FW40 Lower Unit Change

Models Covered	Model Description
921310210	FW40FB 42" 12V

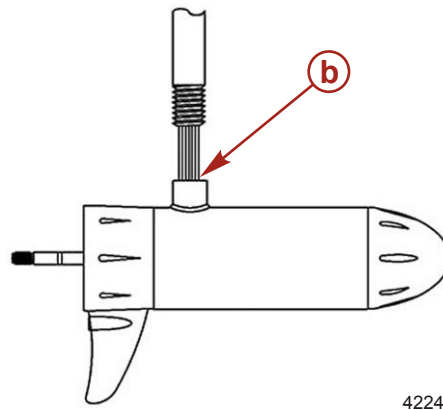
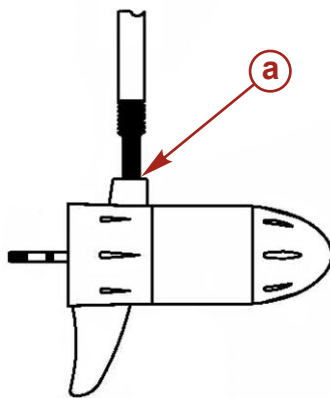
To ensure the weight of the lower unit is distributed evenly across the mount, replace lower unit MPF397042 with lower unit MEF397072.

a - Lower unit MPF397042 – column screws into the lower unit commutator cap.

b - Lower unit MEF397072 – column screws into the lower unit magnet housing.

Model	Replacement	Part Number
FW40FB 42" 12V	Lower Unit	MEF397072
